Service Bulletin 530

Subject: Brake Hose Retaining Clip Removal				
Bulletin Number	Models Affected	VIN Range		Markets Affected
530	Street Twin	Up to	753869	All Markets
	Bonneville T120	Up to	753869	All Markets
	Bonneville T120 Black	Up to	753869	All Markets

1. Lower brake hose retaining clip
2. Upper brake hose retaining clip
3. Front brake hose
4. ABS sensor cable

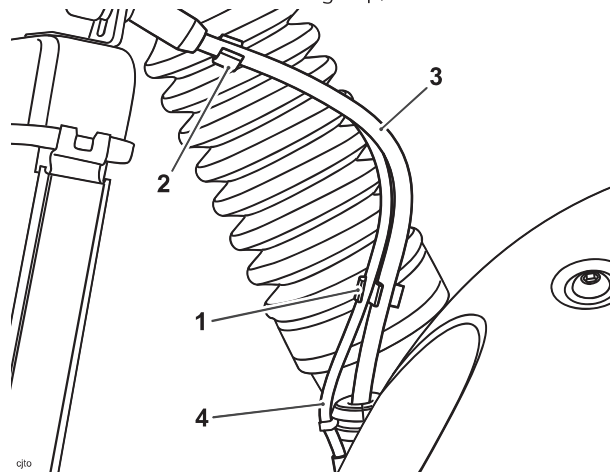
Internal investigations have identified a need to remove one of the front brake hose clips to prevent potential scratching of the front mudguard.

1. Remove and discard the lower brake hose retaining clip, item 1 as shown in the illustration.

Remove the lower front brake hose clip following the procedure described below. If the front mudguard or front brake hose is damaged, contact Triumph Warranty Technical Support for repair instructions.
